INSPECTION OF: Site Scaffoldings

SITE: Aberavon House, Port Talbot, SA13 1 PB

UNIQUE IDENTIFICATION NUMBER: AS 260 Front Elevation

Design Number: 17/RSDL/02/148-2

Design:

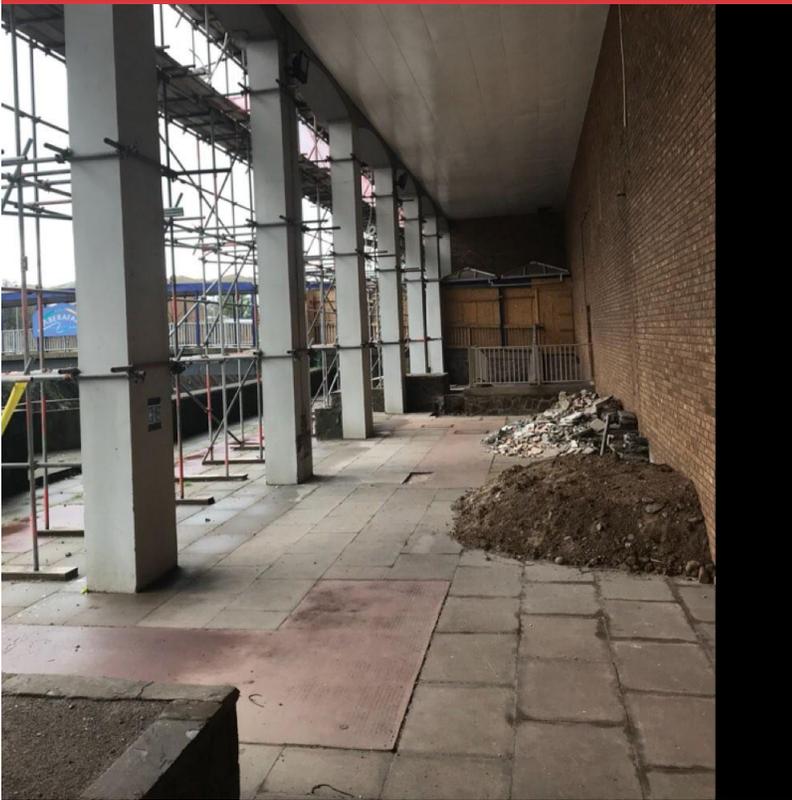
The updated Design for the Front Elevation is showing 37 Bays but 35 Bays have been erected on the scaffold.

The 1st Bay of the Front Elevation is not Face braced due to the position of the Hoist; Bay 5 of the Front Elevation is braced correctly. Bay 6 as per the Design is missing, Bays 10 and 11 of the Design are Bays 9 and 10 on the Front Elevation. Bays 16 and 17 on the Design are Bays 15 and 16 on the Front Elevation. Face Bracing is in Bays 21 and 22 on the Front Elevation but on the Design, it should be placed in Bays 24 and 25. Face Bracing is in Bays 27 and 28 on the Front Elevation but on the Design, it should be placed in Bays 28 and 29. Face Bracing is in Bays 32 and 33 on the Front Elevation but on the Design, it should be placed in Bays 33 and 34.

There is Face Bracing 2 Bays in from the end of the scaffold on the Princess Royal Theatre end of the Front Elevation, on the Design this should 3 Bays in, where the bracings are currently placed, the strength and stability of the scaffold has not been compromised or undermined, the Scaffold Designer has agreed to the Face Bracings being in different Bays to those shown on the Design on the proviso that the ratio of Bays to Bracings, quantity of bracing and quality of materials used are not compromised and are fully compliant with the requirements of TG20:13.

FRONT ELEVATION OUTER SCAFFOLD

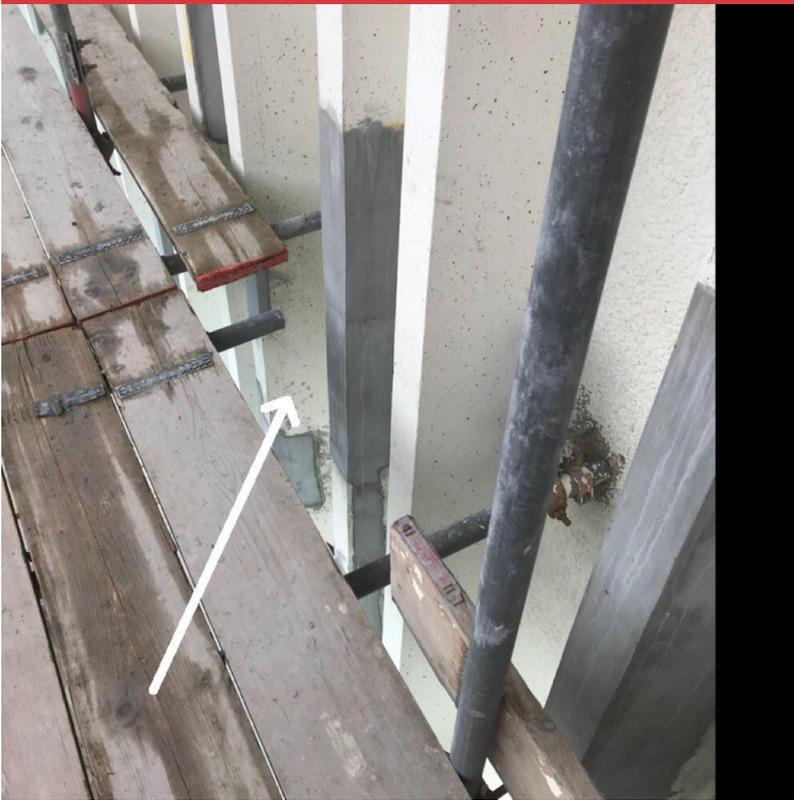
The scaffold on the outside of the Front Elevation has not had the Ledger Sleeves staggered or spliced correctly (in/out, in/out) in order to meet compliance.

FRONT ELEVATION

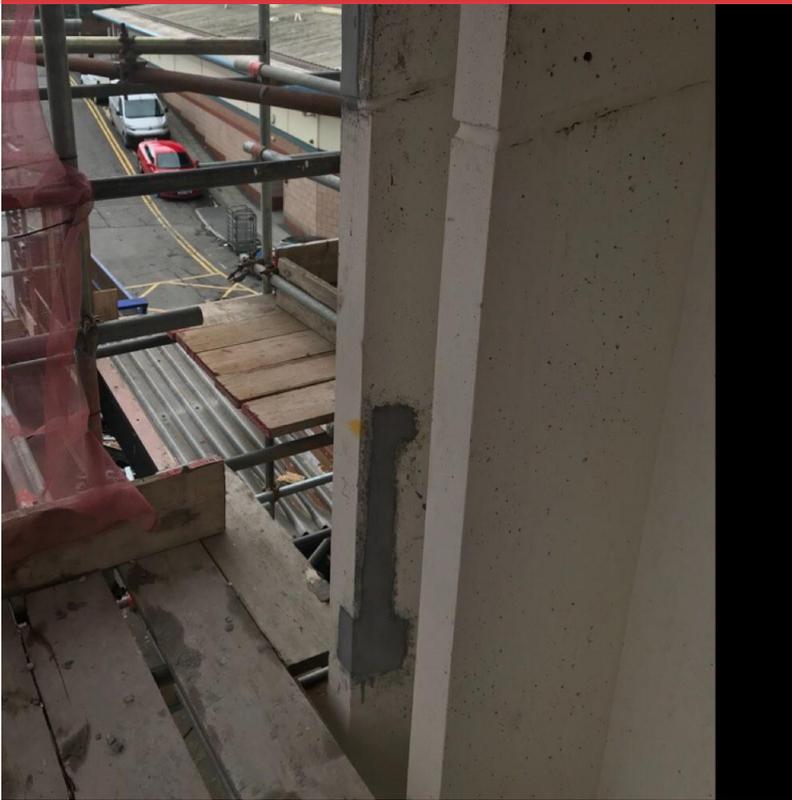
Warped boards have started to become evident in most Working Lifts on the scaffold on the Front Elevation

FRONT ELEVATION

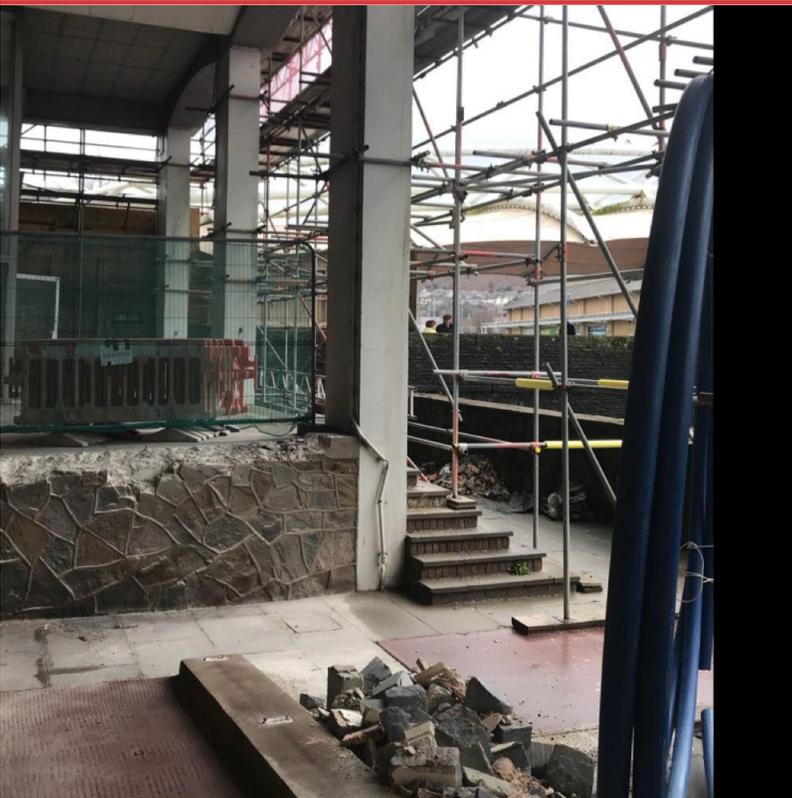
A handrail needs to be put in place in order to minimise the potential of a fall from height

FRONT ELEVATION

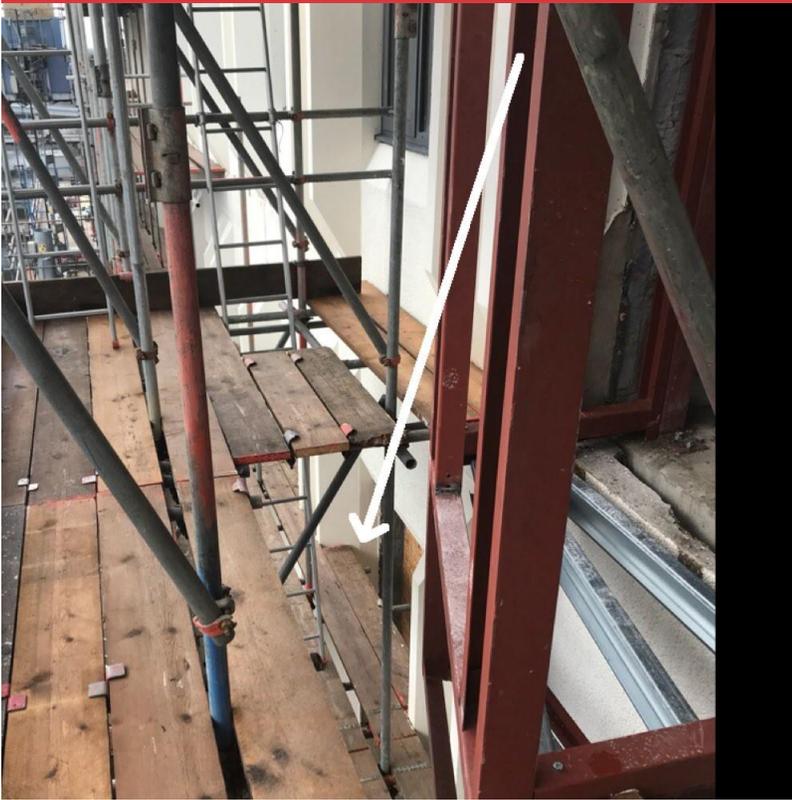
The boards in the photo need to be either nailed down or removed in order for them to not become a tripping hazard

FRONT ELEVATION

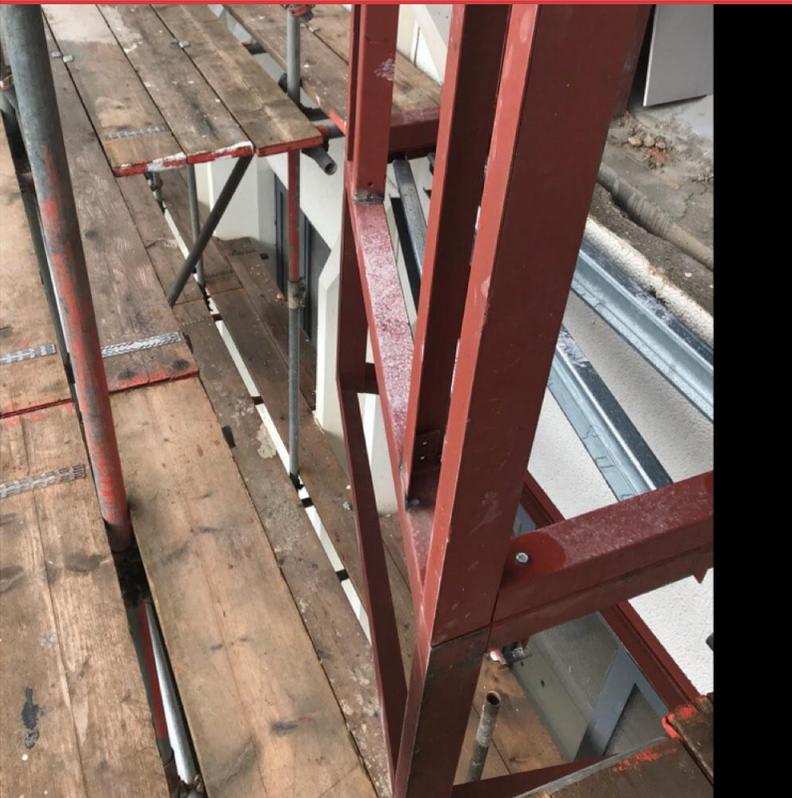
The Steelwork that has been constructed on the scaffold on the Front Elevation has been done so in order to build external Pods, there is a Trap Door missing on this scaffold but also there is an excessive gap between the Steelwork and Working Lift that needs to be monitored and possibly Contractors wearing Fall Arrest PPE when Working in this area.

FRONT ELEVATION

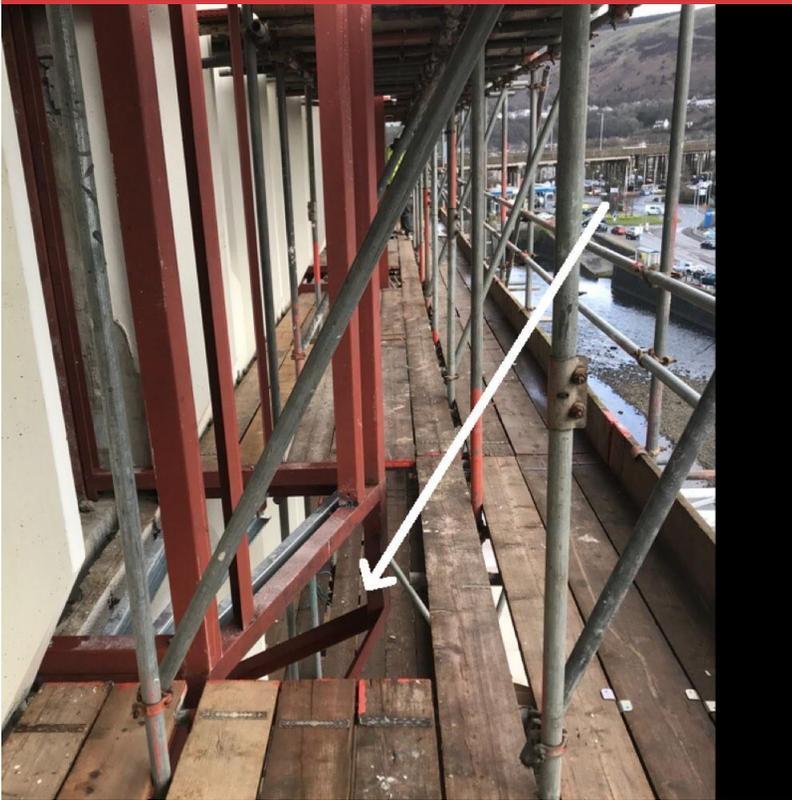
The Steelwork that has been constructed on the scaffold on the Front Elevation has been done so in order to build external Pods, there is a Trap Door missing on this scaffold but also there is an excessive gap between the Steelwork and Working Lift that needs to be monitored and possibly Contractors wearing Fall Arrest PPE when Working in this area.

FRONT ELEVATION

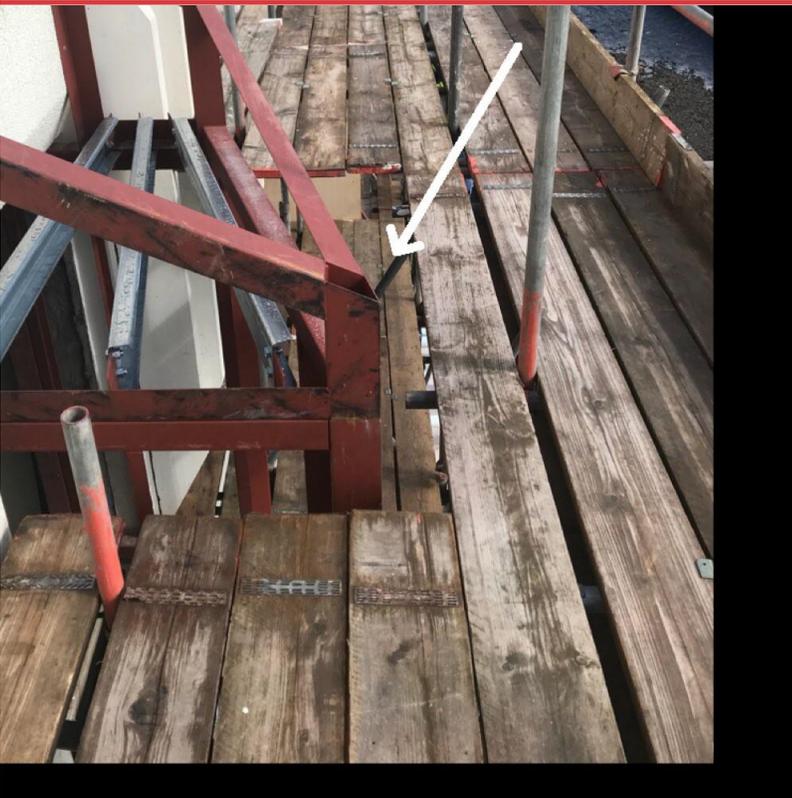
The Steelwork that has been constructed on the scaffold on the Front Elevation has been done so in order to build external Pods, there is an excessive gap between the Steelwork and Working Lift that needs to be monitored and possibly Contractors wearing Fall Arrest PPE when Working in this area.

FRONT ELEVATION

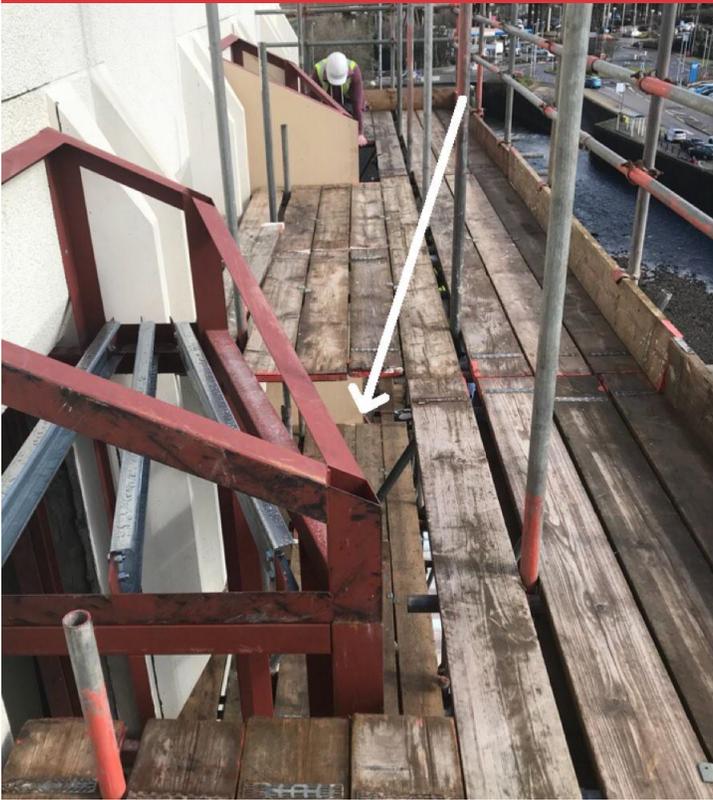
The Steelwork that has been constructed on the scaffold on the Front Elevation has been done so in order to build external Pods, there is an excessive gap between the Steelwork and Working Lift that needs to be monitored and possibly Contractors wearing Fall Arrest PPE when Working in this area.

FRONT ELEVATION

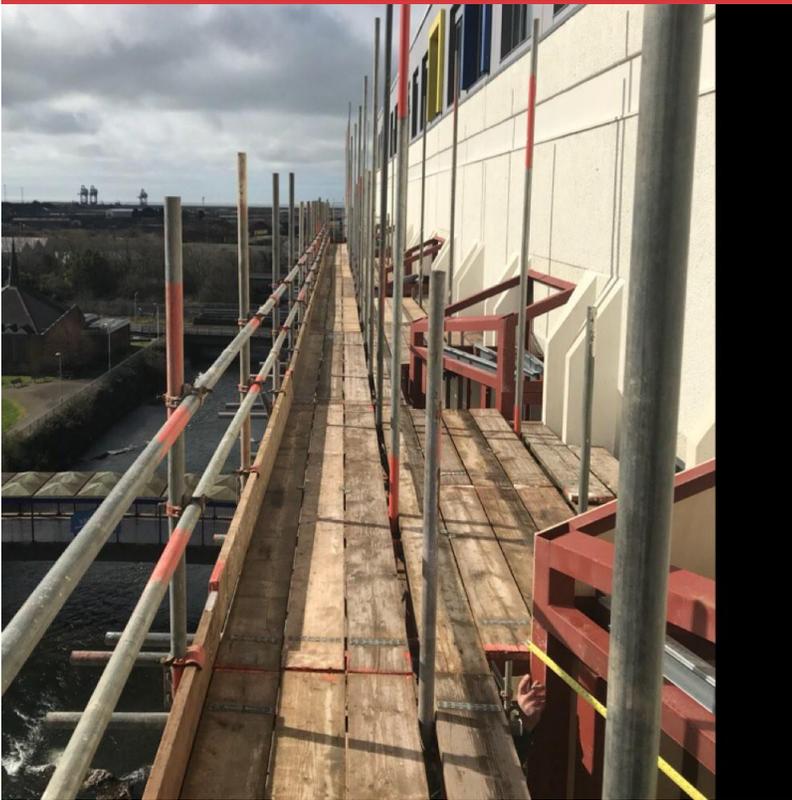
The Steelwork that has been constructed on the scaffold on the Front Elevation has been done so in order to build external Pods, there is an excessive gap between the Steelwork and Working Lift that needs to be monitored and possibly Contractors wearing Fall Arrest PPE when Working in this area.
